**WAPC**

Western  
Australian  
Planning  
Commission

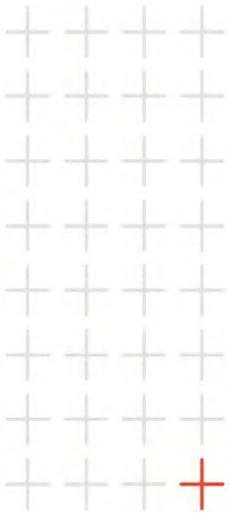
Thank you for considering our submission. Should you require any further information or clarification of the above please contact the undersigned on 0408 614 346.
